Recall Bulletin

PRODUCT SAFETY RECALL

- SUBJECT: Power Steering Hose Routed Incorrectly
- MODELS: 2012 Chevrolet Impala

Correctly Routed Power Steering Gear Inlet Pipe/Hoses are Routed Below the Steering Gear Mount Bolt: (1) Power Steering Gear Inlet Pipe/Hose (2) Steering Gear Mount Bolt (3) Catalytic Converter (4) Cradle

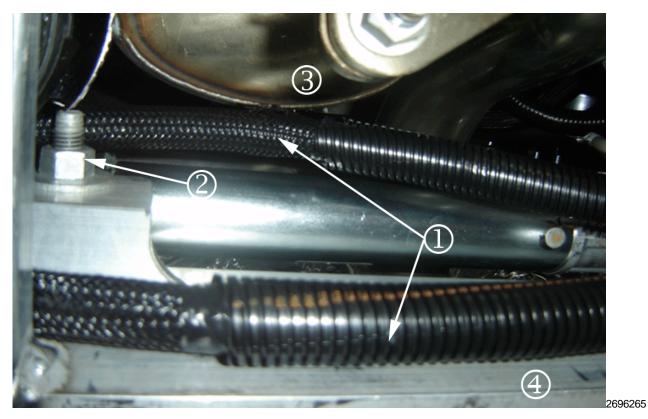
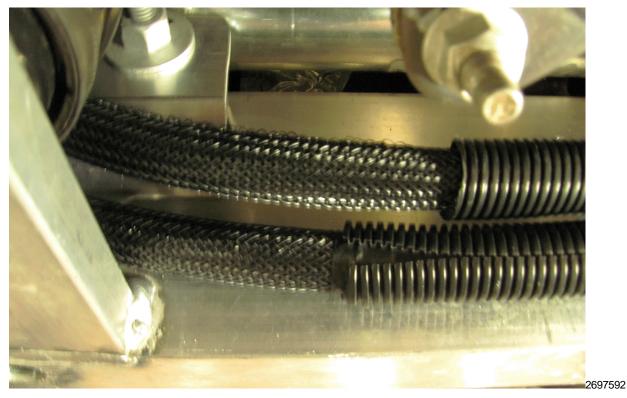
General Motors has decided that a defect, which relates to motor vehicle safety, exists in **certain** 2012 model year Chevrolet Impala vehicles. The upper power steering hose on some of these vehicles may have been misrouted so that it can come in close proximity to and/or contact the catalytic converter. With the engine on, heat from the catalytic converter may melt the power steering hose. If this occurs, power steering fluid could flow onto the catalytic converter, and an engine compartment fire could occur.

Note: Incorrectly routed power steering gear inlet pipe/hoses include one or both hoses routed above the steering gear bolt. The hoses may contact the steering gear bolt and/or the catalytic converter. REPLACE the power steering gear inlet pipe/hoses if the hoses are incorrectly routed.

• If the power steering gear inlet pipe/hoses are NOT routed correctly, remove and replace the power steering gear inlet/pipe hoses. Refer to *Power Steering Gear Inlet Pipe/Hose Replacement* in SI. After installing the power steering gear inlet pipe/hoses, ensure that the hoses are routed below the steering gear mount bolt. Refer to *Correctly Routed Power Steering Gear Inlet Pipe/Hose* illustration. Proceed to *Protective Sleeve Installation* in this bulletin after installing the power steering gear inlet pipe/hoses.

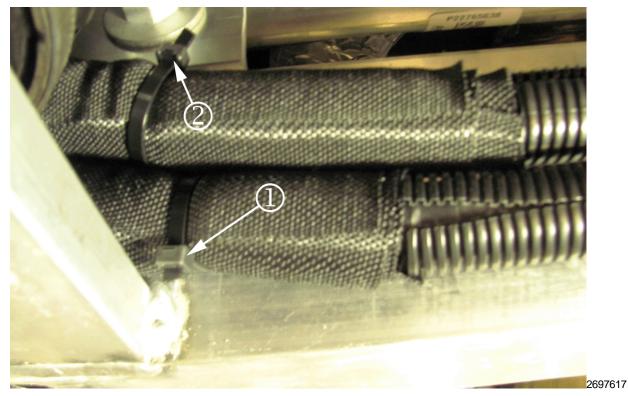
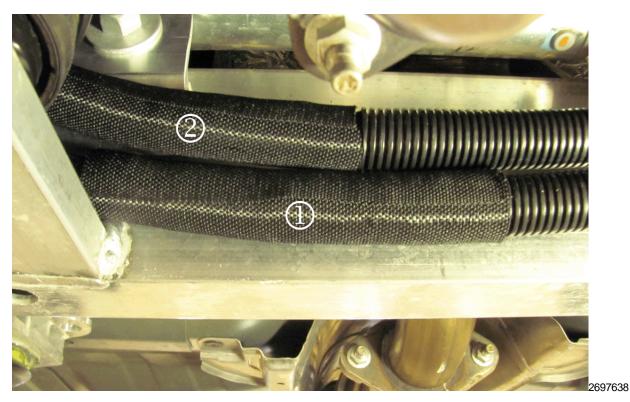
Note: The purpose of the protective sleeves on the lower hoses is to protect the hose from the edge of the cradle side rail.

- 3. Place the second piece of protective sleeve on the lower hose (1).
 - 3.1 Begin wrapping the protective sleeves around the hard plastic conduit portion of the hose.
 - 3.2 Slide both protective sleeves toward the passenger side of the vehicle. The protective sleeve should end adjacent to the hard plastic conduit. The protective sleeve should NOT overlap the hard plastic conduit portion of the hose.
 - 3.3 Ensure that the overlapping edges of the protective sleeves are facing down and away from the cradle.

- The tie strap should line up with the edge of the cradle side rail.
- The tie strap should be fastened snug. The purpose of the tie strap is to hold the protective sleeves in place. However, do NOT fasten the tie strap too tight to ensure that it does NOT cut into the hose.
- Locate the connector end (1) of the tie strap away from the other hose.
- 4. Tie strap the protective sleeves in place.

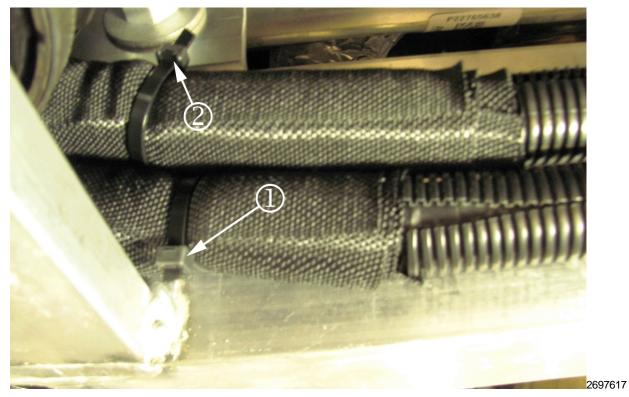
Caution: Ensure that the protective sleeves are installed past the rear edge of the power steering gear bracket and powertrain mount to protect the hose from the front and rear edge of the power steering gear bracket and powertrain mount. The protective sleeve should end

adjacent to the hard plastic conduit. The protective sleeve should NOT overlap the hard plastic conduit portion of the hose.

- 6.2 Slide the protective sleeves past the rear edge of the power steering gear bracket and powertrain mount.
- 6.3 Ensure that the overlapping edges of the protective sleeves are facing down and away from the cradle.
